CITY OF HENDERSON

DEPT. OF UTILITY SERVICES

SUBJECT: Approved Materials List – Meter Box Lids

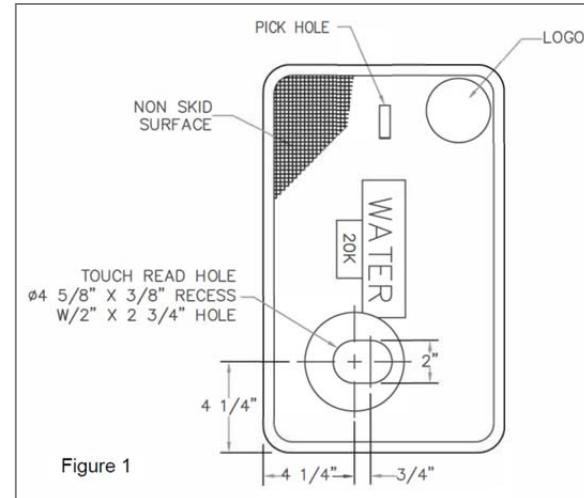
The City of Henderson has recently started using a new automatic meter reading sensor that has different dimensions than the touch reading sensor. To accommodate the new and the old meter sensors, the sensor hole for the meter box lids must be modified.

The dimensions for the sensor hole for the new meter box lids are as follow:

- 4 5/8" x 3/8" Recess with 2" x 2 3/4" Hole  
(Please refer to Figure 1 for reference)

Effective January 3, 2017, the City will require all meter box lids to accommodate the new and the old touch read meter sensors. Current meter box lids on the Approved Materials List will not be accepted.
